NUCLEAR RADIATION CENTER

April 26, 1982

W.S.U. RELICENSE REVIEW QUESTIONS RESPONSE

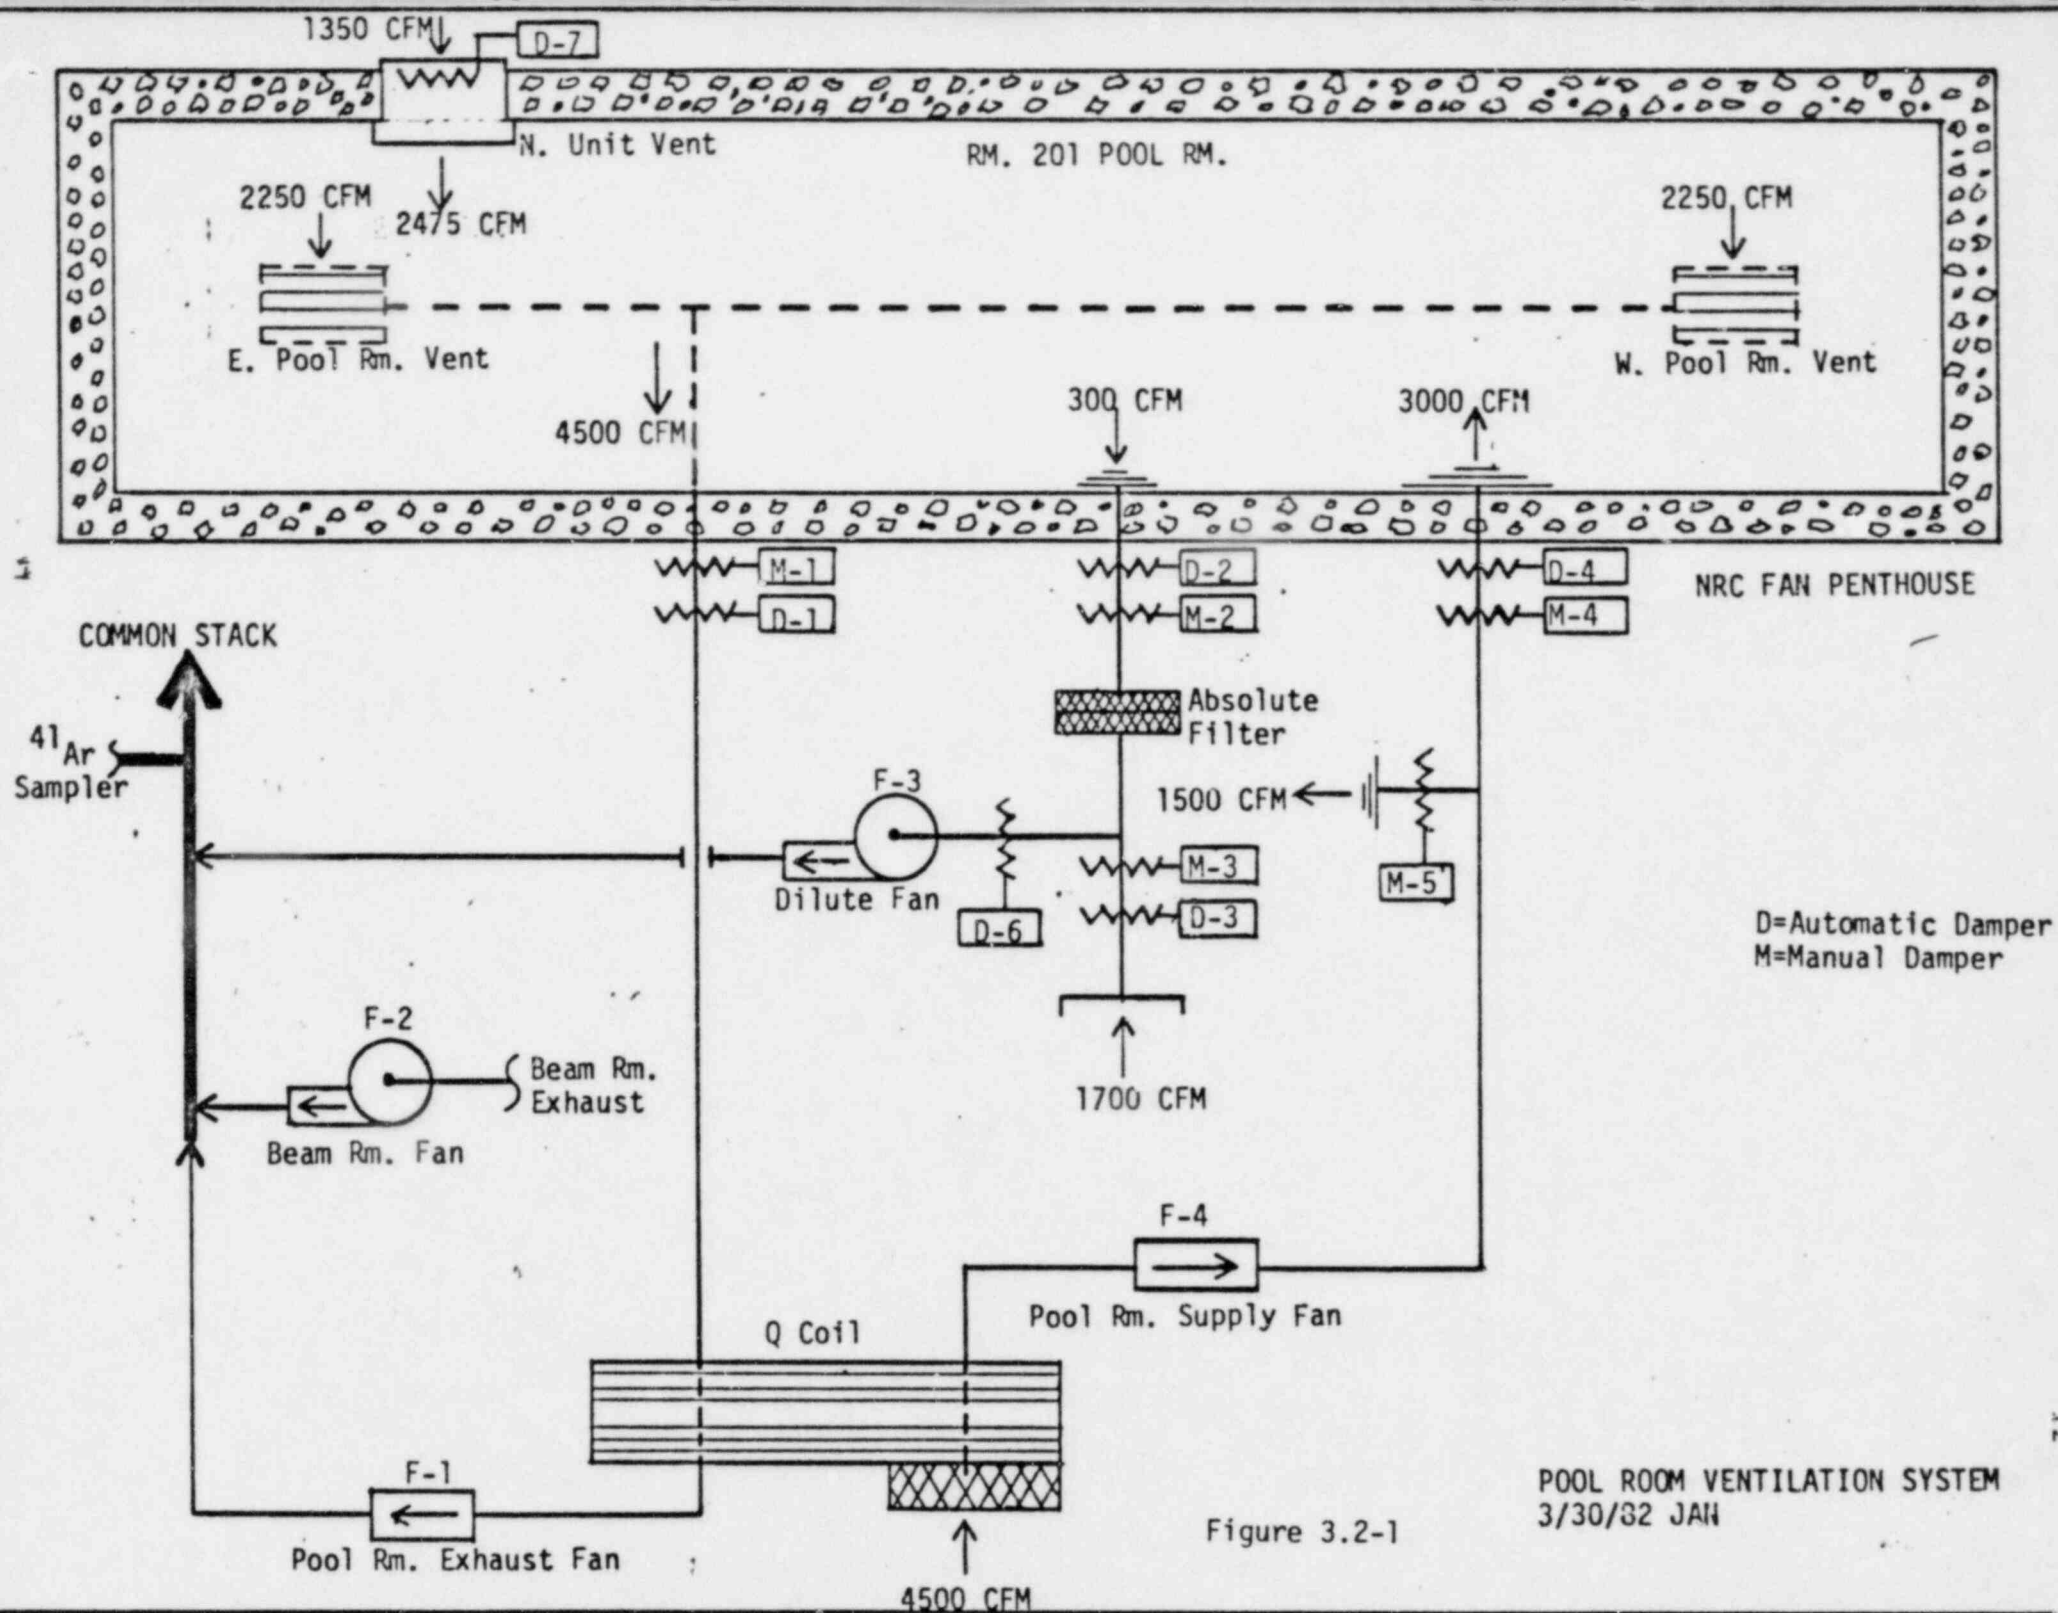
3. Describe the reactor room ventilation system, including filter types and efficiencies. Specify exhaust stack height and location with respect to the balance of the Nuclear Radiation Center Complex.

4. Is the flow rate in the effluent stack monitored? If not, how is the operational status verified?

ANSWER: The reactor area ventilation system is shown in the attached drawings 3.2-1 and 3.2-1A from the SAR. A recent modification to the ventilation system increased the exhaust rate from the pool room from 2000 to 4500 CFM during normal operation.

The ventilation system operation modes are shown in Figure 3.2-1A. During normal operation 4500 CFM of air are exhausted from the pool room and discharged up the monitored stack. All the control dampers are spring loaded to shut in the event of a loss of control air pressure or AC power. In the event of a scram, the system automatically shifts to the isolation mode. Return to the normal mode requires the reactor operator to reset the vent system.

In the event of a CAM alarm the vent system shifts to the dilution mode. This mode may also be entered manually by operator intervention. In the dilute mode 300 CFM of air is exhausted from the pool room, passed through an absolute filter, mixed with 1700 CFM of outside air, and then discharged to the atmosphere.

The exhaust stack is located in the central part of the facility roof and extends about 36" above the roof. The absolute filter in the dilution mode line consists of two SGN C1 Caisson Filter boxes and standard C1 24" x 24" x 11-1/2" absolute filters. The Dop test on these filters yields a filter efficiency of 99.97 for .3 micron particles.

ANSWER: The actual flow rate is not measured but each of the four fans shown in Figure 3.2-1, F1 to F4, have paddle type flow switches installed that give a positive indication of the presence or absence of air flow. The flow indicator lights are located in the reactor control room.
